Panel Report

Port Phillip Planning Scheme

Amendment C104

1-7 Waterfront Place, Port Melbourne

Figure 5 Subject Land Interfaces

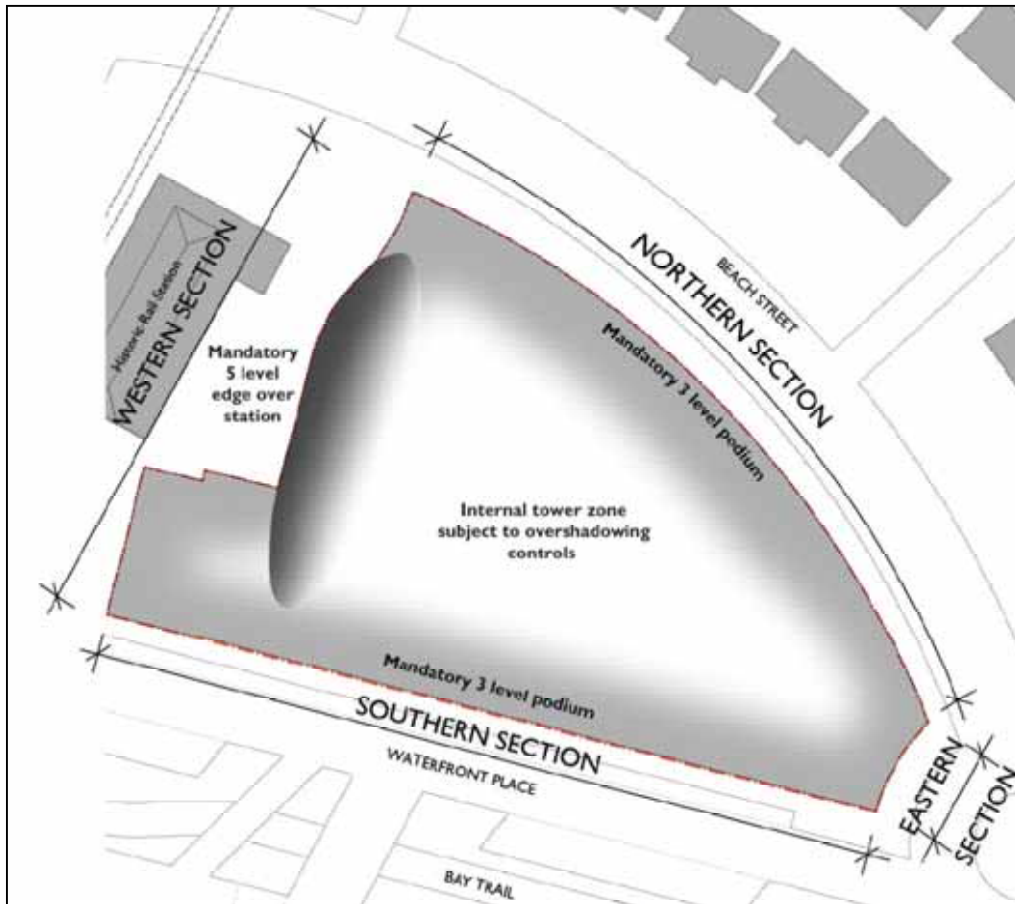
The Panel concludes that mandatory height provisions should dictate the perimeter, street wall parts of the building and that the height of the internal portions should be driven by shadowing provisions. These are illustrated in Figure 5 below. There was no strategic basis to justify the requirement for Pedestrian Laneway 5B through the centre of the Subject Land or to justify the prescriptive nature of how the 5% public open space should be provided.

1. Amend Schedule 23 to the Design and Development Overlay, as shown in Appendix C, to:
 - b) Replace the exhibited building height requirements in Design requirements B1, B2 and B3 with:

“As shown in Figure 1 to this schedule, building heights must not exceed:

- 5 storeys and 17.5 metres in the western central section (the station interface)."
- c) Replace the car park built form requirements in Design requirements B5 with:
"Where car parking is contained within the podium levels, it must be sleeved with activated spaces or the facade designed with high quality architectural screening to completely disguise the car park use of the areas."

- d) Replace the third point in Design requirements B3 with:
"Where 5 storeys are proposed at the station interface, the upper two storeys must be set back behind the northern and southern 3 storey podiums and designed so that the podiums are the dominant forms from the street and promenade views, as shown in Figure 1 to this schedule."

- e) Replace the fourth dot point in Design requirements B2 with:
"Tower forms must be set back from the podium edges so that the podium reads as the dominant form from the street views. The narrow edges of the tower form may be located close to or even touch the podium edge, subject to a high-quality design outcome that does not cause the tower to dominate over the podium.
Tower forms shall be set back from the 5 storey western edges so that this edge reads as the dominant form over the station."

Figure 1

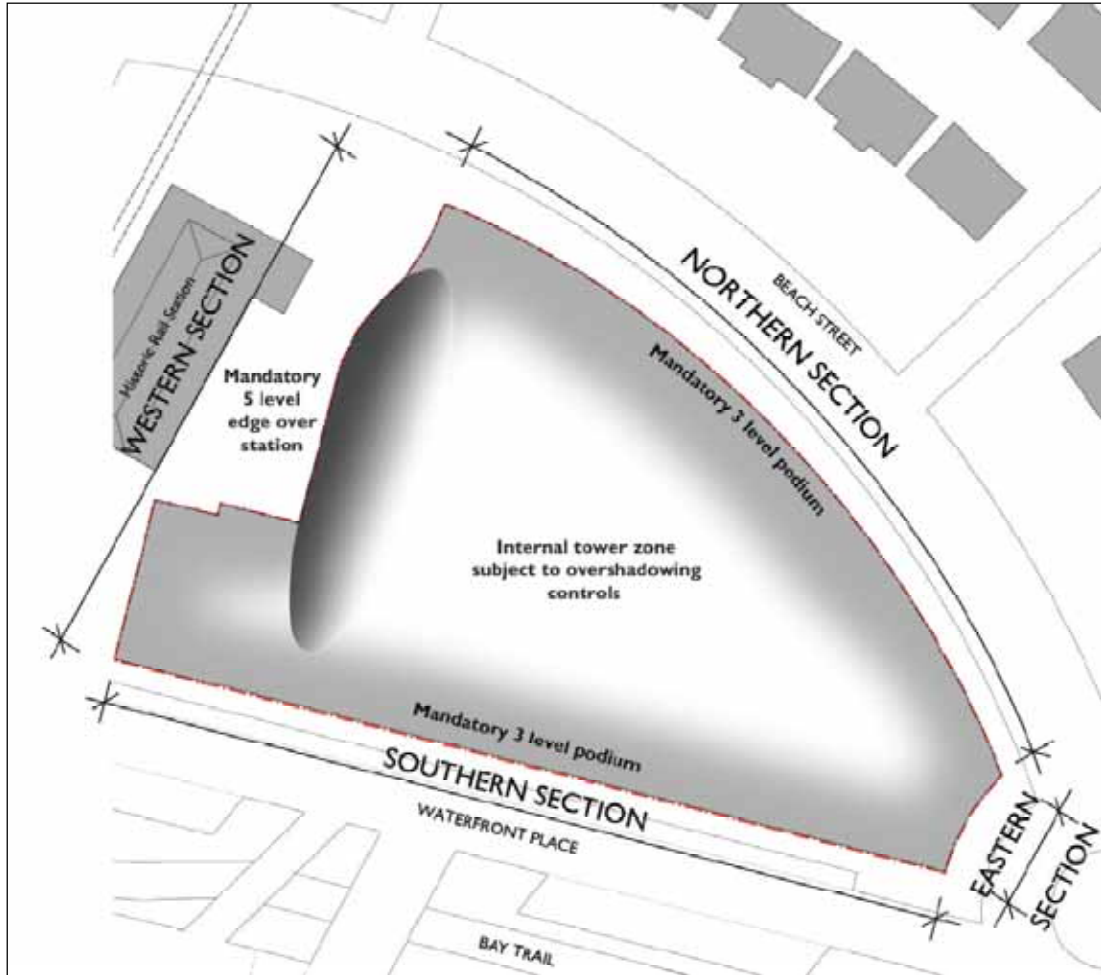
- Figure 1 should be simplified to illustrate the principles embodied in the requirements, rather than a particular design.
- Remove the requirement for linkages through and public open space within the Subject Land.
- Remove the mandatory 10 storey height limit in the eastern end of the Subject Land and replace it with a performance-based control that prioritises design qualities over scale.
- Amend design requirement B3 to require development to have minimal visual impact on the station building.
- Amend design requirement B5 which requires on-site parking to be at basement so that it allows 'sleeved' podium car parking.
- Remove the design requirements seeking a highly activated frontage to Beach Street.
- Reword the design requirements relating to adaptable buildings to encourage, rather than require adaptable buildings.

- As shown in Figure 1 to this Schedule, building heights must not exceed:
 - 3 storeys and 11 metres in the northern section (the Beach Street interface)
 - 3 storeys and 11 metres in the southern section (the Waterfront Place interface)
 - 5 storeys and 17.5 metres in the western central section, the station interface A permit.

- Massing and location of built form must generally be in accordance with Figure 1 of this Schedule.
- Any tower form should ~~utilise~~ use design techniques to avoid a monolithic or bulky appearance. These may include vertical recesses, ‘breaks’ in the form, lightweight materials, transparency and other techniques
- Any tower form is to be elongated or linear in plan, oriented generally north-west to south-east, so as to appear most slender as viewed from the beach to the east of Waterfront Place.
- Detail design and materials of the tower form should reinforce its visual lightness and reduce the sense of bulk or mass.

- Building height in the western area of the site must be in accordance with the range of heights shown in Figure 1 to this Schedule.
- Building heights must not exceed:
 - ~~3 storeys in the northern section, the Beach Street interface~~
 - ~~5 storeys in central section (facing the rear of heritage Station building)~~
 - ~~7 storeys in the southern section, the Waterfront Place interface.~~
 - 3 storeys and 11 metres in the northern section (the Beach Street interface)
 - 3 storeys and 11 metres in the southern section (the Waterfront Place interface)
 - 5 storeys and 17.5 metres in the western central section, the station interface A permit.

- Massing and location of built form must generally be in accordance with Figure 1 of this Schedule.
- ~~Tower forms should generally be set back significantly from the podium edges. Tower form may be located close to, or over, the podium edge at the narrow tower ends, subject to a high quality design outcome.~~
- Tower forms must be set back from the podium edges so that the podium reads as the dominant form from the street views. The narrow edges of the tower form may be located close to or even touch the podium edge, subject to a high-quality design outcome that does not cause the tower to dominate over the podium.
- Tower forms shall be set back from the 5 storey western edges so that this edge reads as the dominant form over the station.

- ~~▪ Built form in proximity to or adjoining the heritage rail station must be of low-medium scale (up to 5 storeys) to ensure the railway station is not “dwarfed” when viewed from Port Plaza.~~
- Where 5 storeys are proposed at the station interface, the upper two storeys shall be set back behind the northern and southern 3 storey podiums and designed so that the podiums are the dominant forms from the street and promenade views, as shown in Figure 1.
- As shown in Figure 1 to this Schedule, building heights must not exceed:
 - 3 storeys and 11 metres in the northern section (the Beach Street interface)
 - 3 storeys and 11 metres in the southern section (the Waterfront Place interface)
 - 5 storeys and 17.5 metres in the western central section, the station interface A permit.
